223 ELM STREET
OAKWOOD HISTORIC
DISTRICT (HOD-G)

APPLICATION FOR A CERTIFICATE OF APPROPRIATENESS – STAFF REPORT

085-18-CA 223 ELM STREET

Nature of Project: Implementation of master landscape plan; replacement of front walk; installation of a side yard walk; installation of retaining wall; and installation of a drainage system; remove crape myrtle tree

223 ELM ST. - drainage layout dwg.

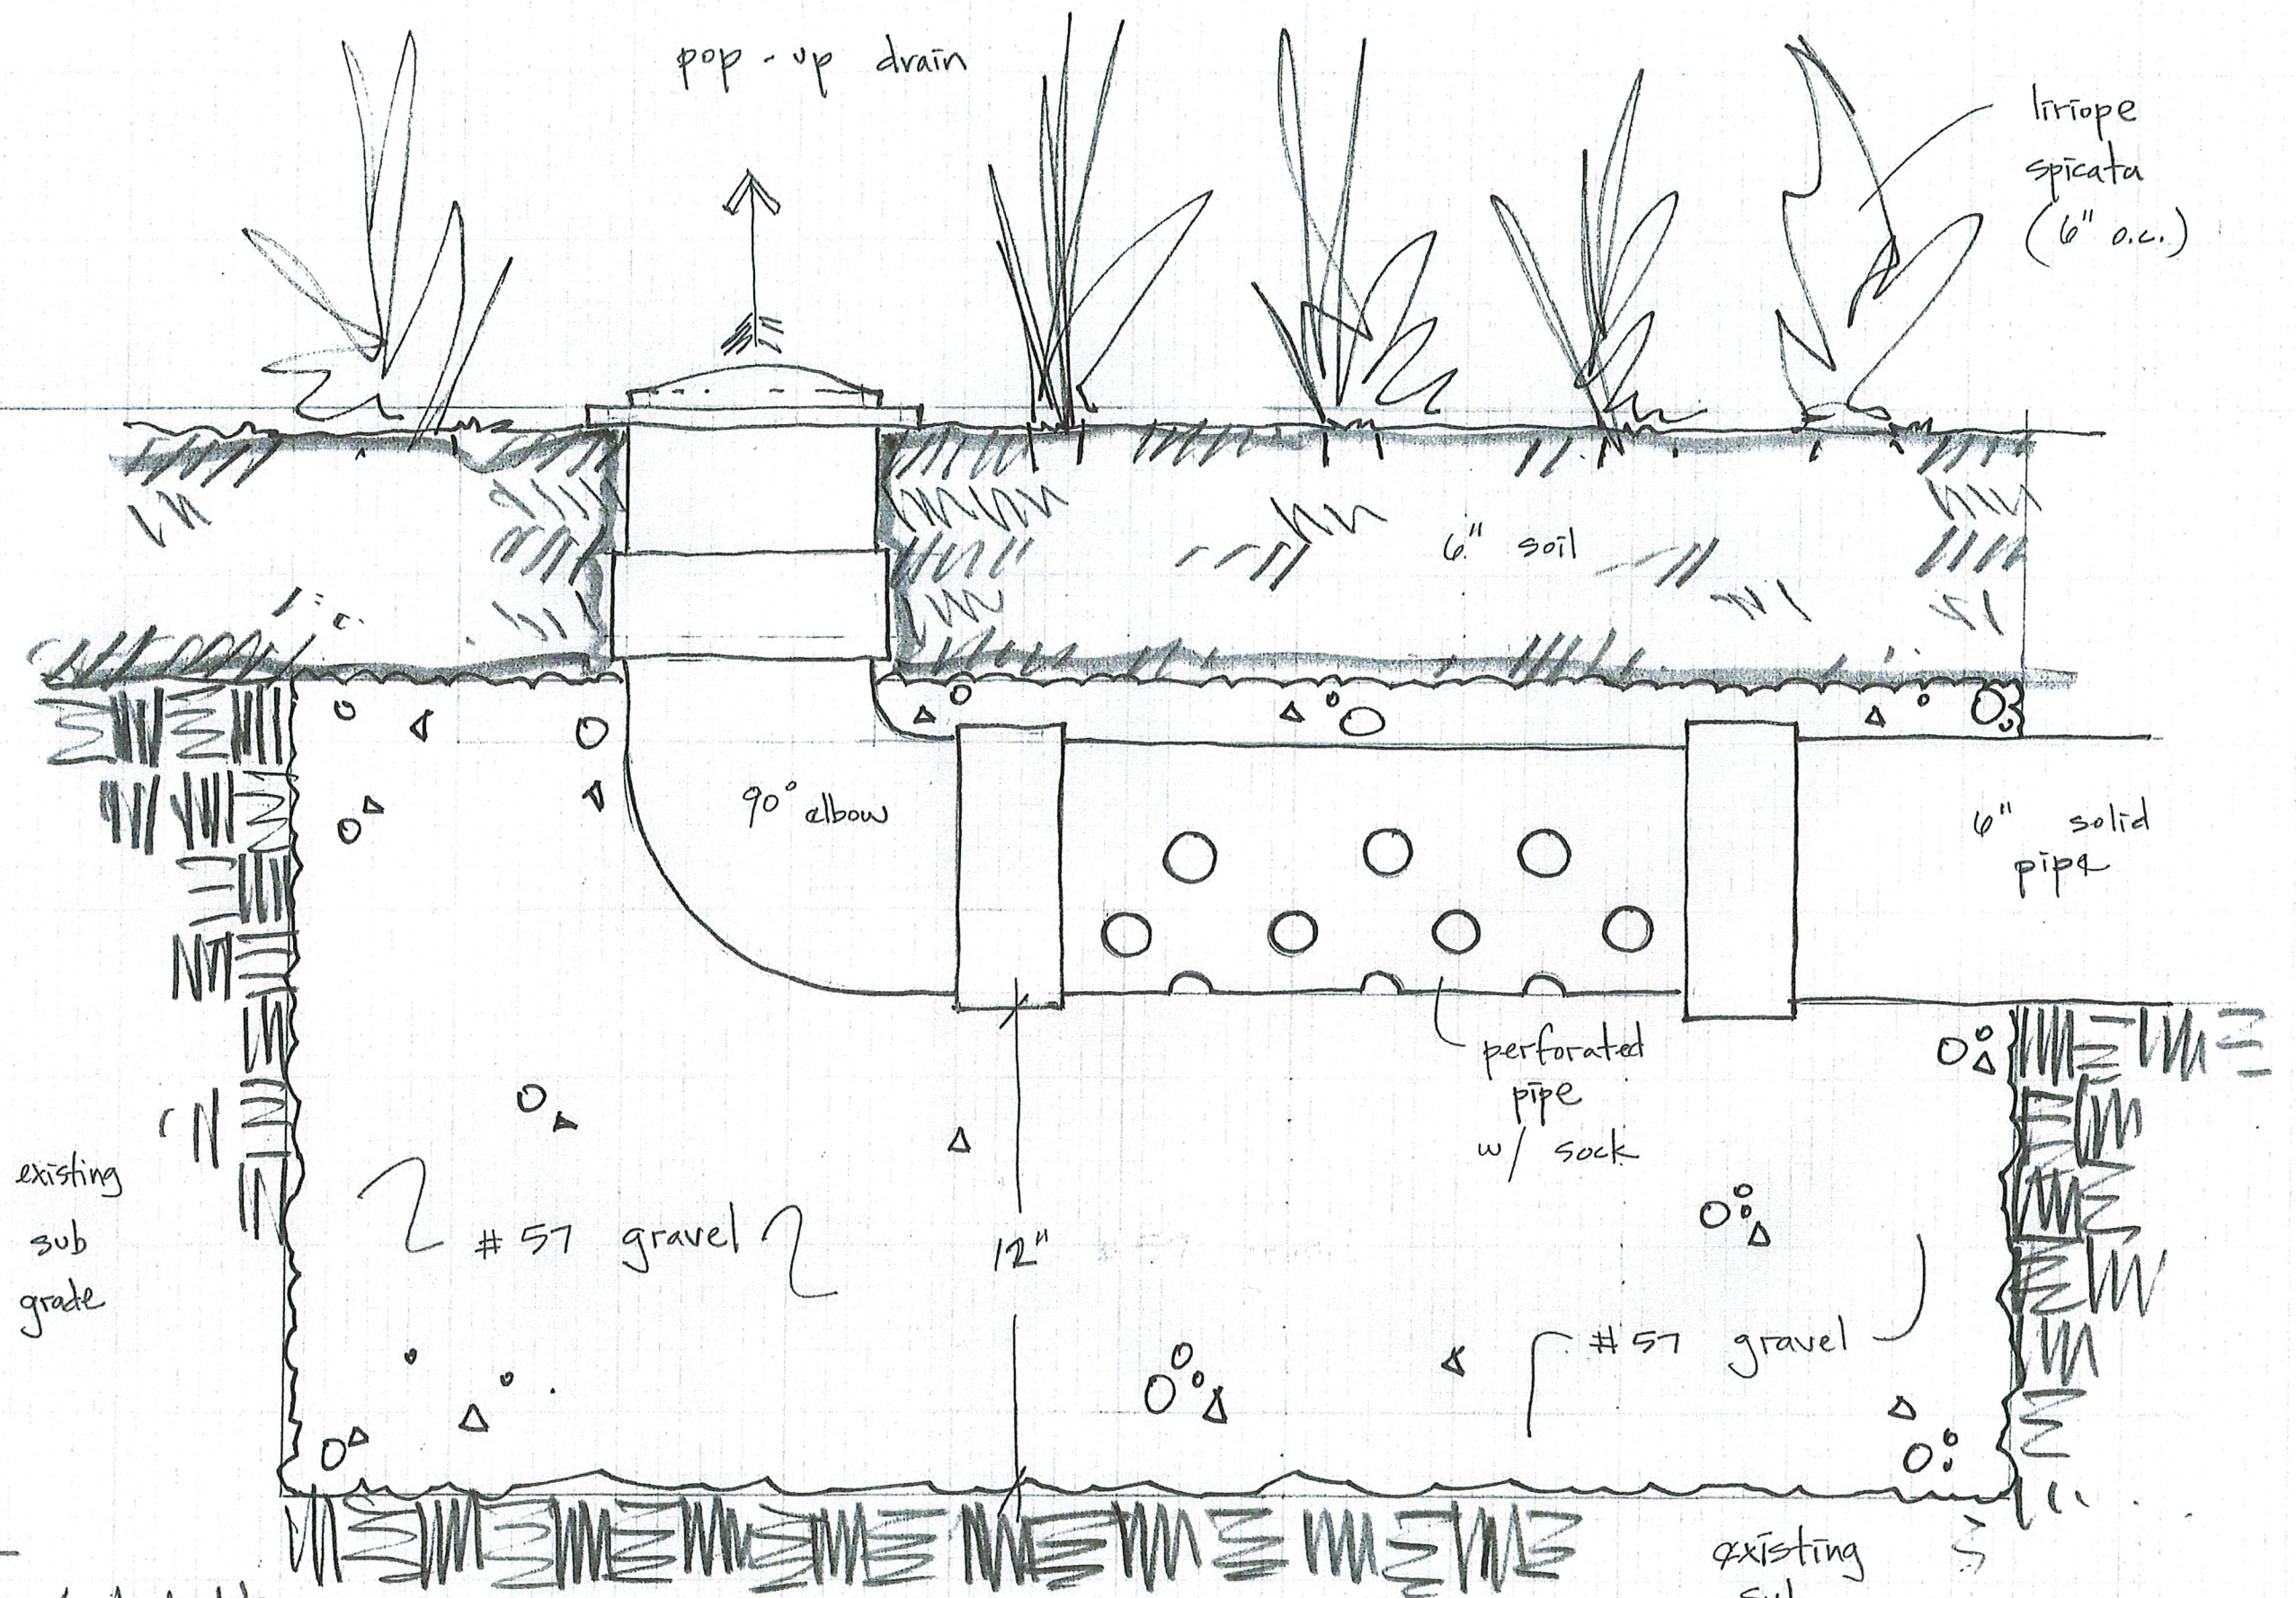
3. Please provide drawings and/or manufacturer's specifications as to what the pop-up daylighting will look like. **Attached.**
4. Please submit digital photographs of the current conditions of the landscaping. **Will send in separate email.**
